**Subject:** Open Letter to Mayor and Council on Vancouver Views

Re: February 1, 2011 Regular Council: Implementation of Vancouver Views and Opportunities for Higher Buildings Downtown

**View Cone E1: Cambie Bridge to Crown/Grouse [Find it in VanMap](#)**

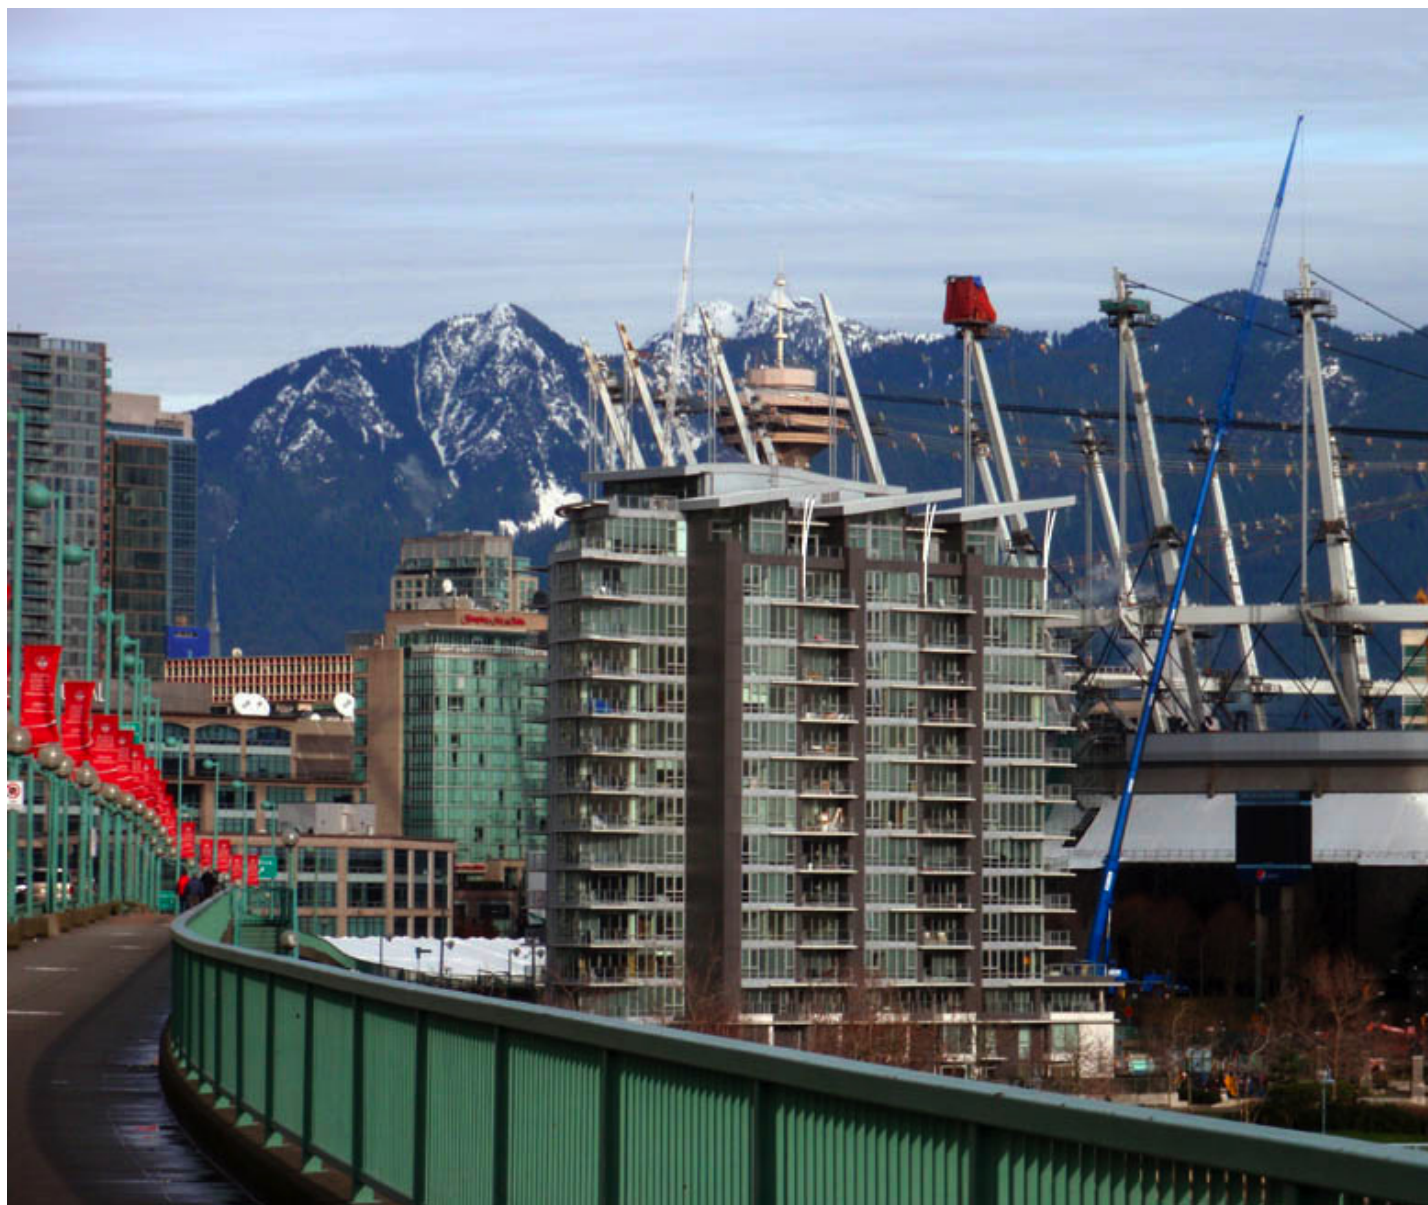
The view 'E1' from the Cambie Bridge would have been an excellent comparison to see the impact of recent changes in the city. Below is the 'current' photo from the city's web page (11am on January 27th). Also attached are two real world photos taken on January 26th for a comparison. The zoomed in version of the photo clearly shows that there has been significant intrusion lately into this protected public view. None of this was communicated to the public. All existing protected views should have been reviewed to verify compliance with the protected view corridor policy.

Furthermore, as of 11am on January 28th, the View Point elevation is still listed as 21.83 m (163 feet). One of these numbers is obviously wrong. In reality, 21.83 metres is approximately 71.6 feet, while 163 feet is approximately 49.7m. The errors in the conversions were pointed out on January 20th during my presentation (second speaker), and the errors still have not been addressed for this view and for many of the other officially protected public views (list at end). This is a key oversight, as the city's web page contains what are supposed to be official descriptions of the protected views.

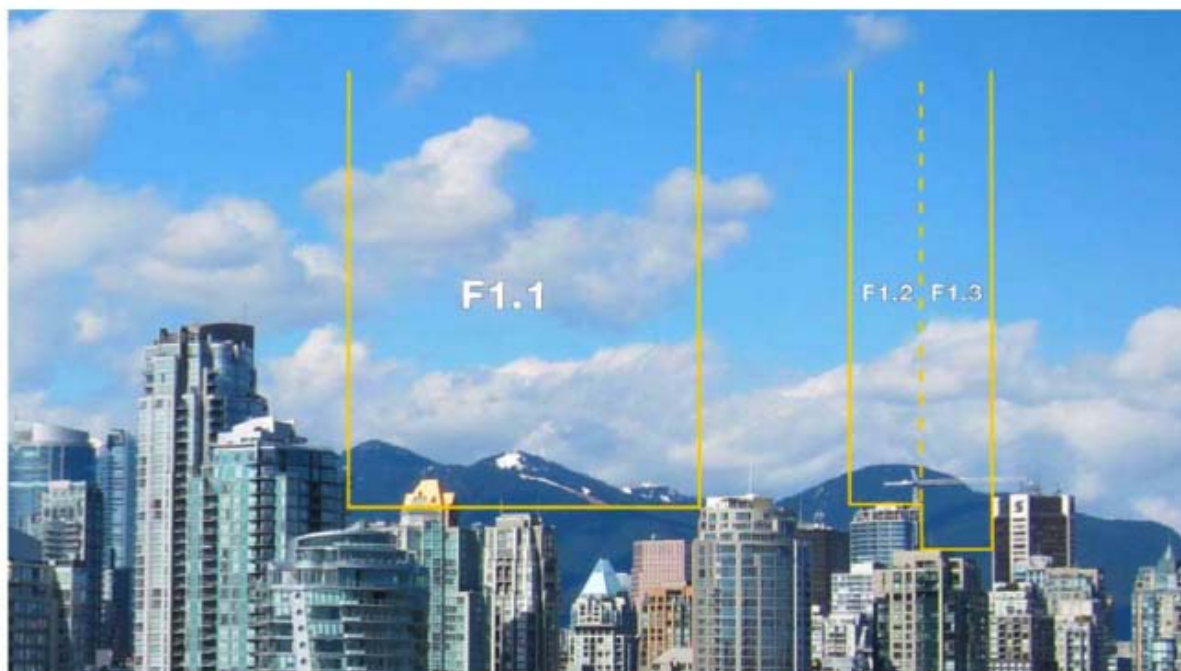
There are shortcomings in some of the proposed new view corridors. These proposed view corridors do not contribute much to view protection. In fact, they appear to be “reverse-engineered” to fit existing height controls in Chinatown and DTES.

**View F1: CHOKLIT PARK to Grouse & Mount Fromme**

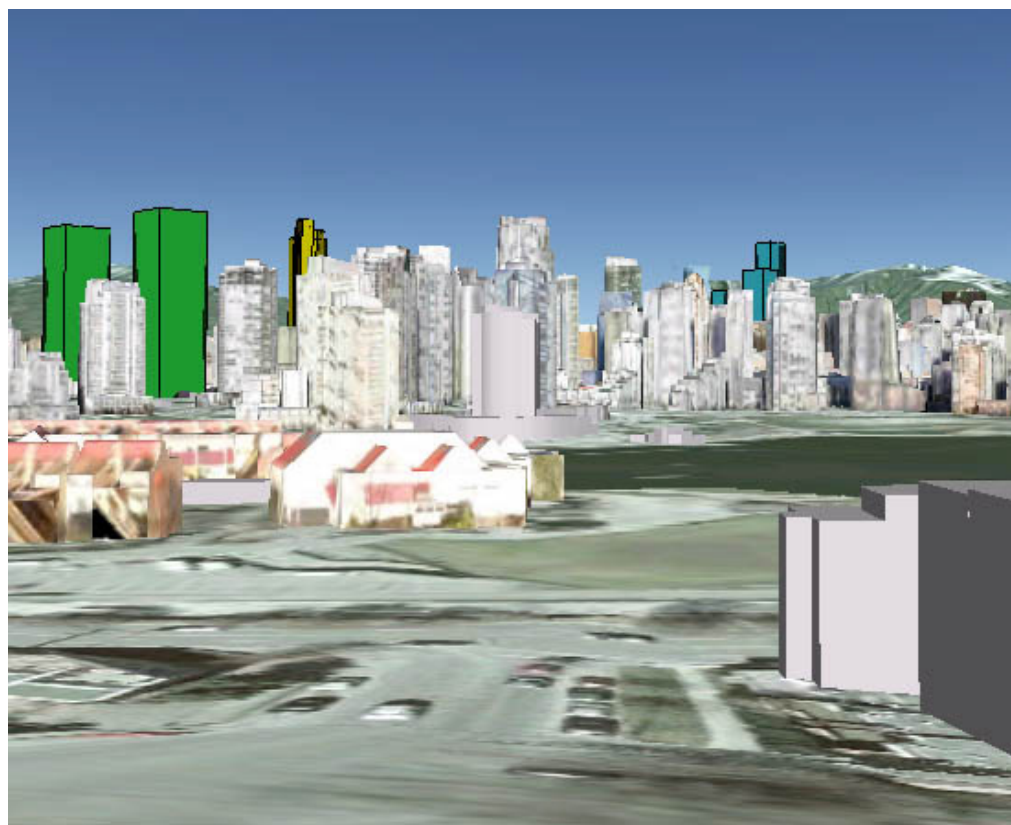
The one small sliver of a view introduced over the downtown from Choklit Park is described incorrectly. The written description of the view states it is from the centre of the 'Upper Plaza' of the park at Spruce and 7th. Photographs in the field suggest that a photo taken from another location (from the Lower Plaza) was used to illustrate view F1. There are considerable legal implications here due to the incorrect description.

Above: Photo from the Centre of the Upper Plaza of Choklit Park (Right hand side of views F1.2 and F1.3 partially obscured by branches (there are branches in front of the Scotia Tower) Below: photo from staff report.

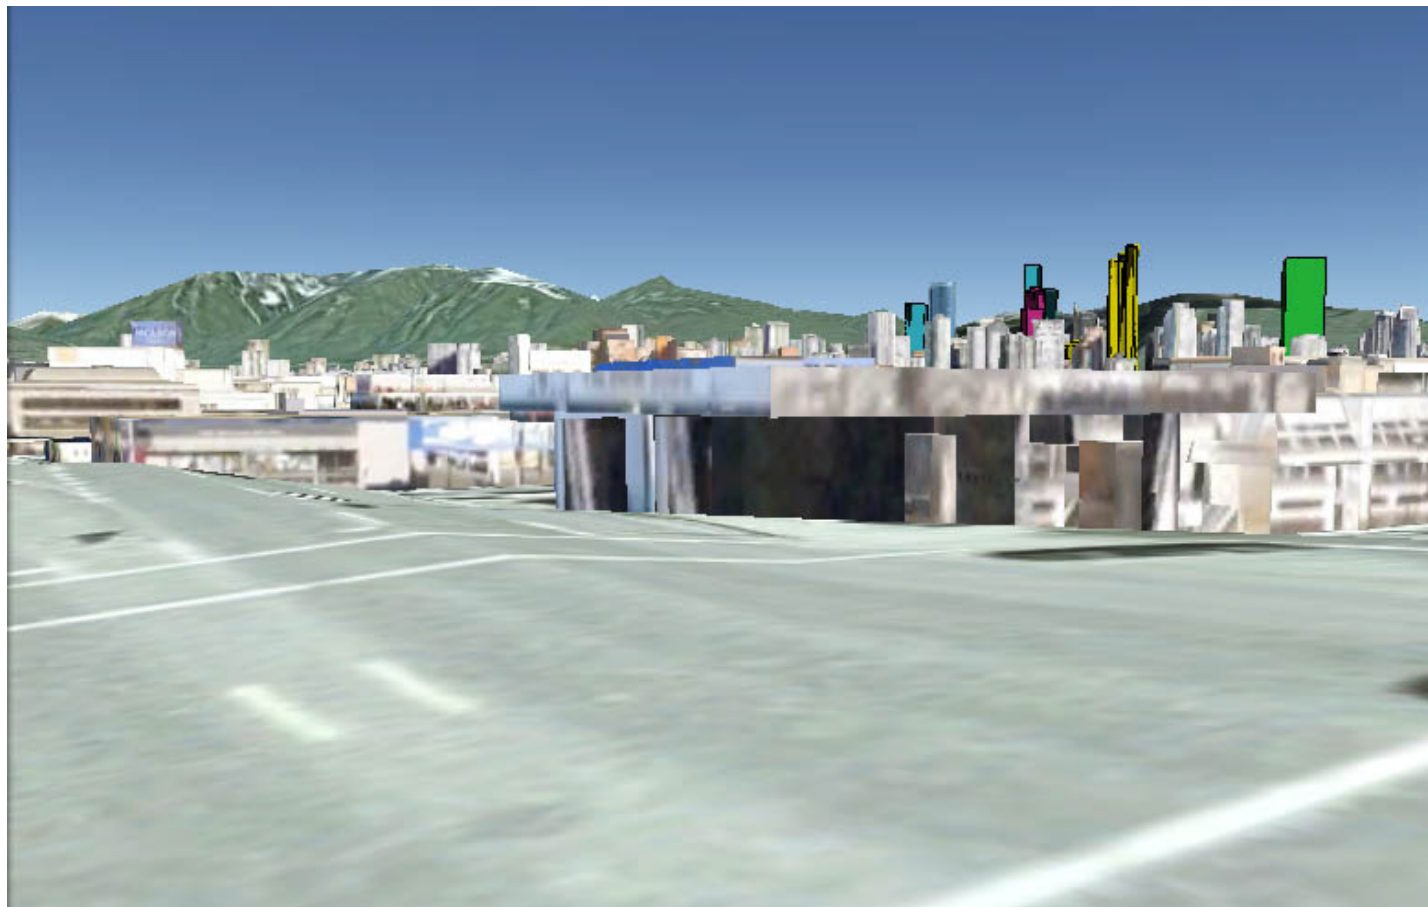
In the neighbourhood around this viewpoint, there are significant PUBLIC VIEWS of the mountains that will indeed be affected by many of the proposed developments. Such is a view from 7th and Oak (Google Earth simulation, same colour scheme as used in staff report, photo calibrations are near end of this summary).

Above: Panel from October 2010 Public Consultation (Vanier Park) Below: Staff report, released Dec 10th, 2010 (Spanish Banks)

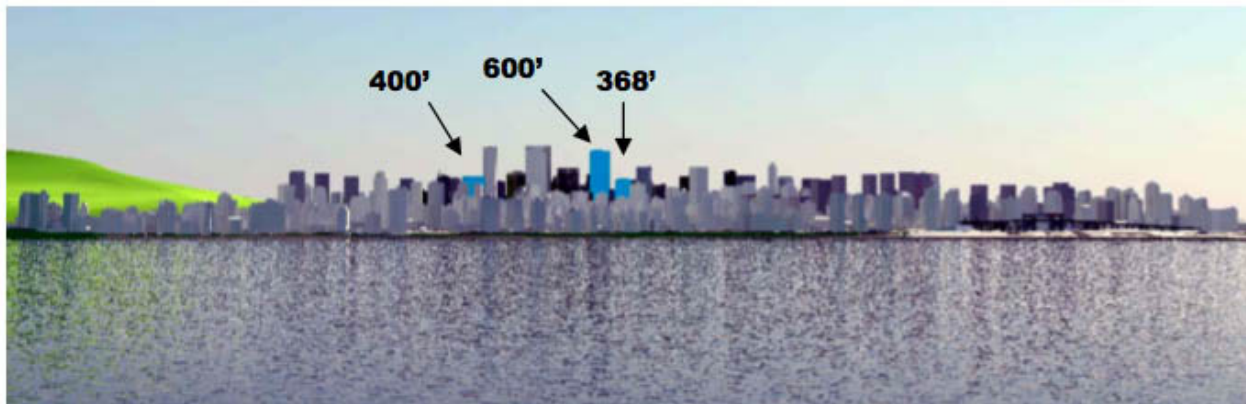
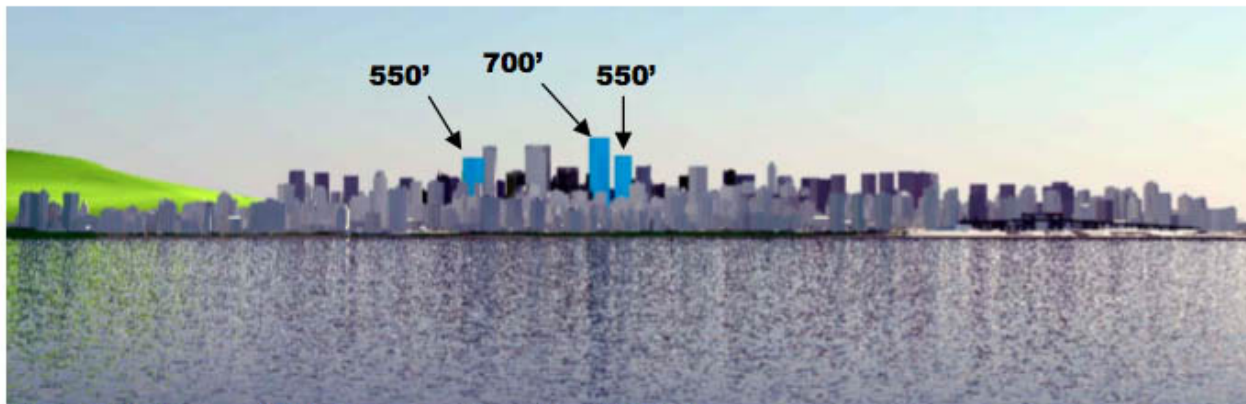
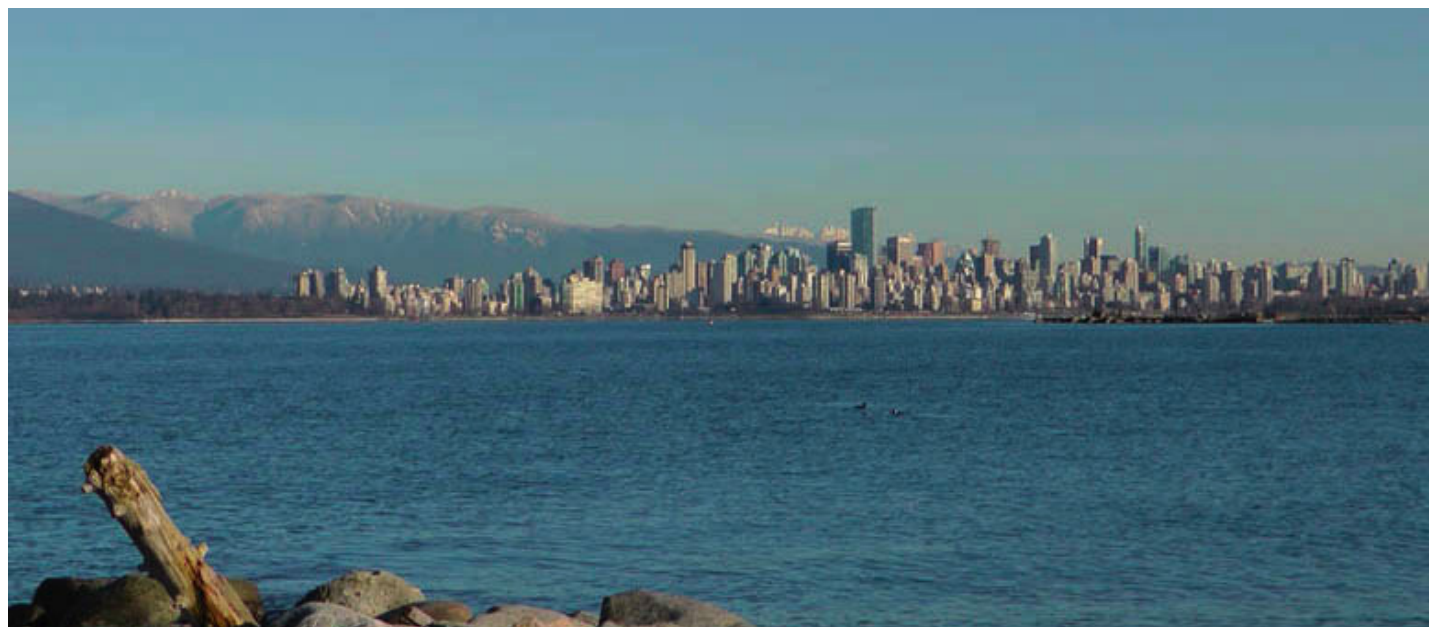
On Panel 4 (October 2010 public consultation), there are two images with the label 'VIEW FROM VANIER PARK'. Then in the staff report released to the public on December 10th, 2010, two images are labelled to be from 'Spanish Banks'.

These images appear to be rendered from the same point, and not from two different parks. Furthermore if the views are indeed from Spanish Banks then the public are still misled. There is also the issue of the mountains in the view to consider; the images suggest that the mountains END over part of the West End towards the left side of the rendering. The image presented by staff erroneously shows no mountains above the Central Business District, and planning staff claimed on December 16th that the mountains are part of the computer model.

As demonstrated at the Citizen's forum on Jan11th, there are INDEED MOUNTAINS that are visible behind part of the CBD. Staff have failed to make any subsequent corrections, and persisted in using this

Colouring by Staff (Granville Loops) above, recoloured towers below:

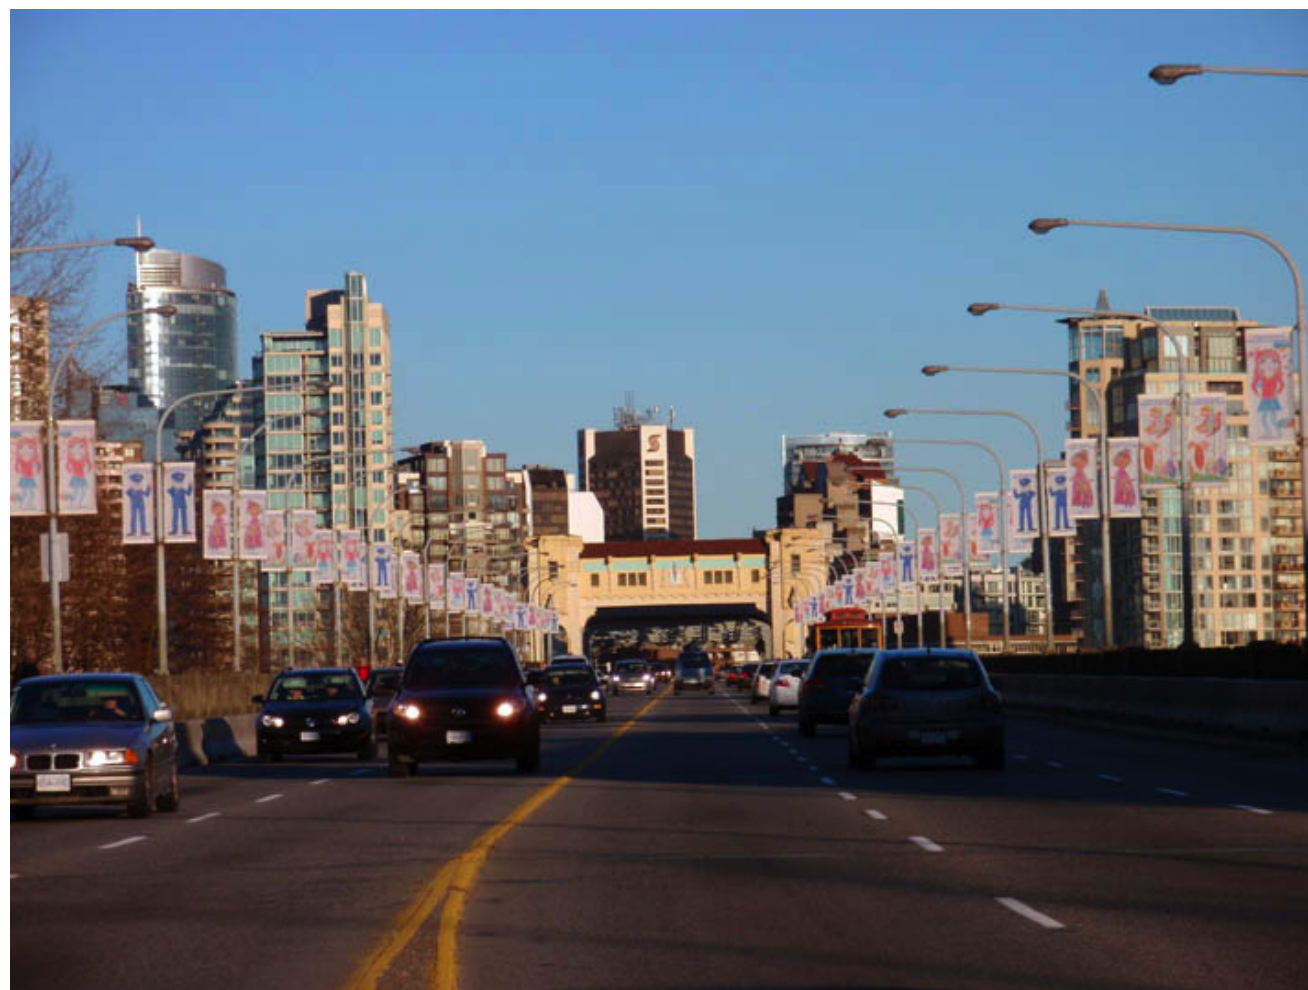
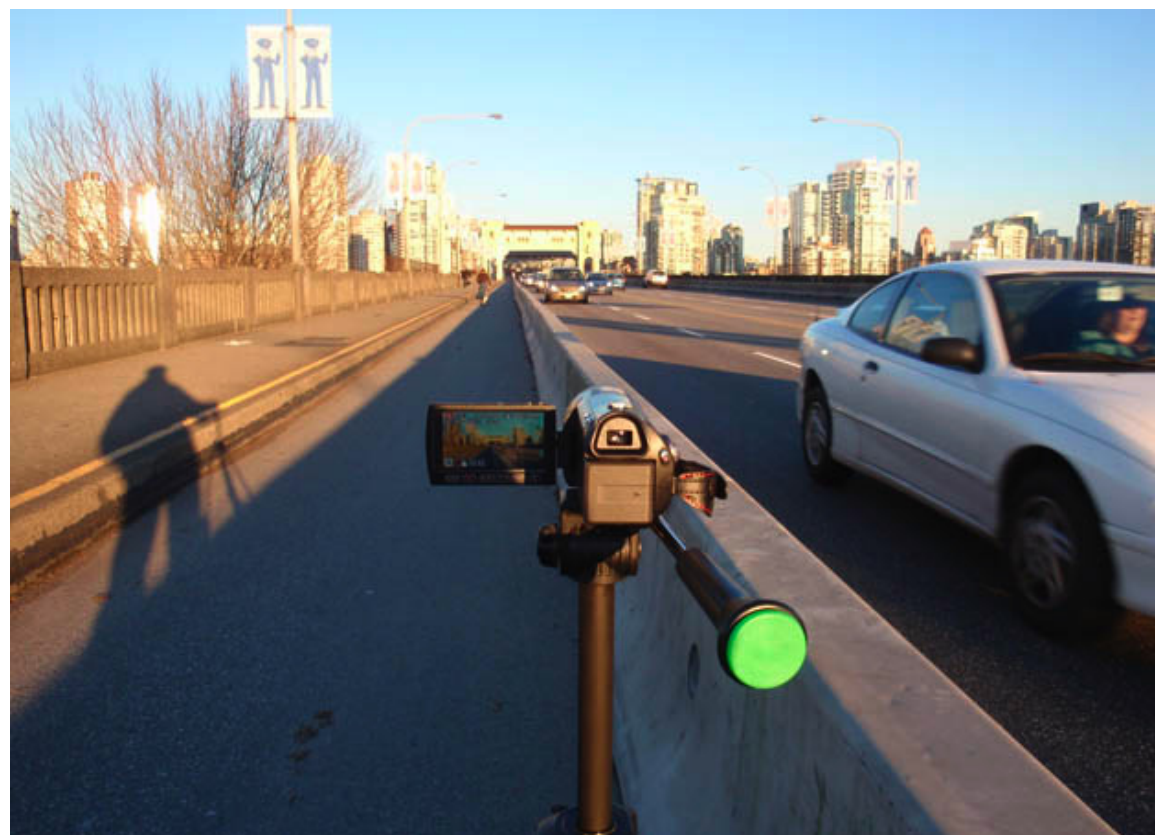
Staff have used other misleading images in both the public presentation panels and the final staff report. Panel 5 (Oct 2010 Public Consultation) and Page 10 of the final staff report use green coloured buildings in the renderings of the Granville loops proposal. Whatever their reason for choosing that colour, we know that green blends in with the mountains and could lead people to underestimate the real visual impacts of the proposed buildings (illustrated in Citizen's Forum with an alternate colour). Thus, a more sincere effort would choose a color other than green.

Above: rendering used by staff, higher than car level (helicopter / floating view) Below: photos from several points along and before the Burrard Bridge

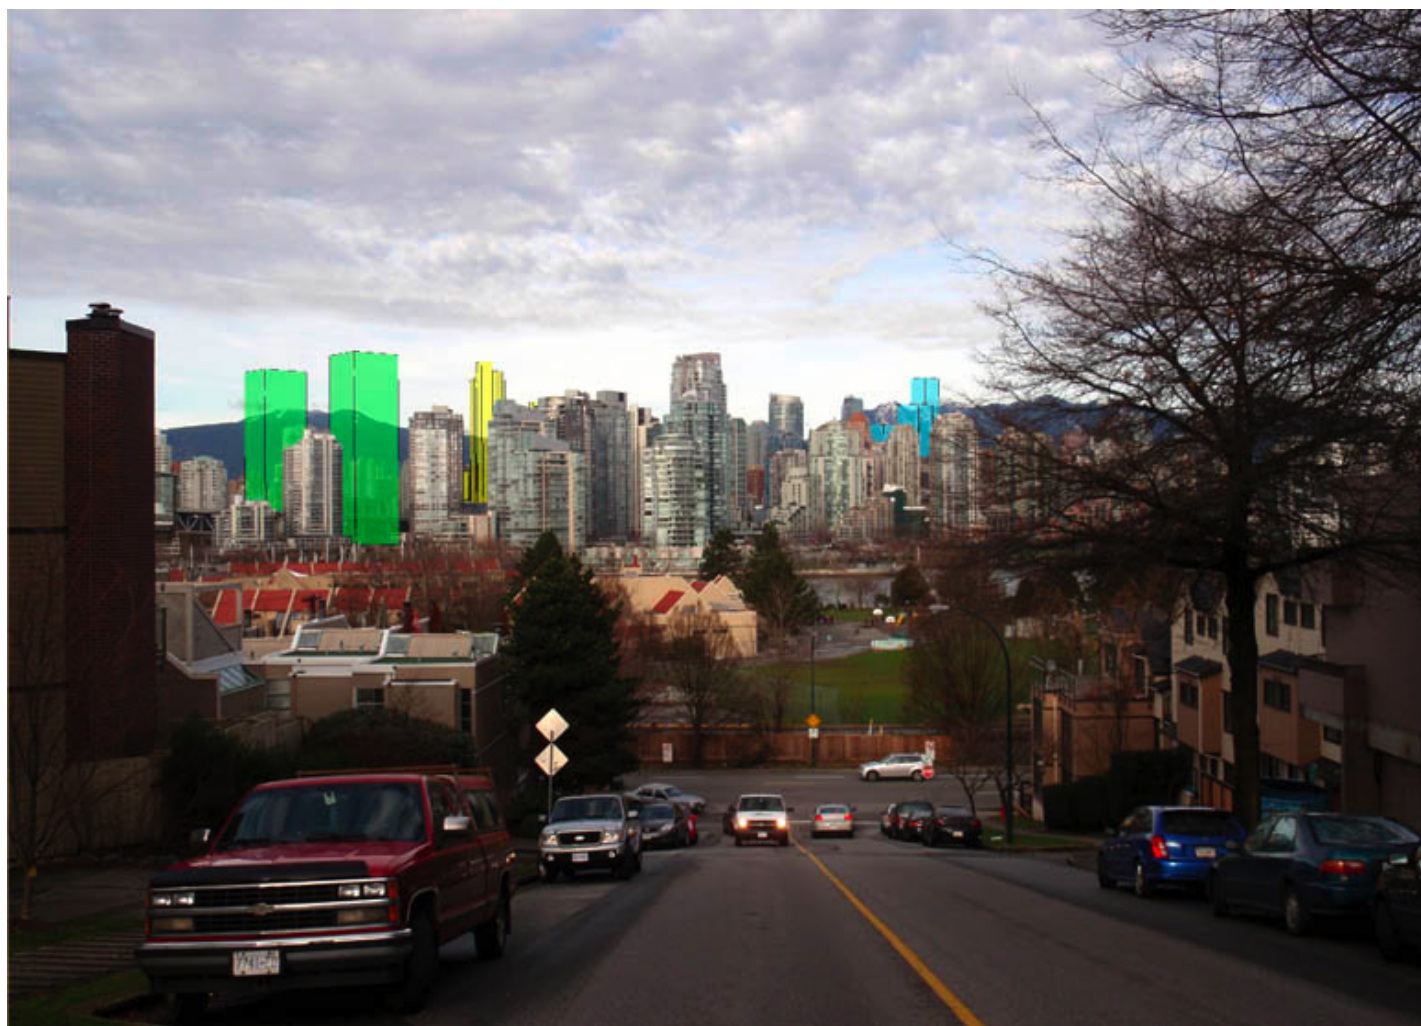
Page 9 of the staff report and the final Panel 6 (public consultation) show a misleading view from Burrard Bridge from a height that would never be seen by an observer. This view appears to be a helicopter point of view, and was discussed in detail at the Citizen's Forum on Jan11th (additional photos from the field, around car level).
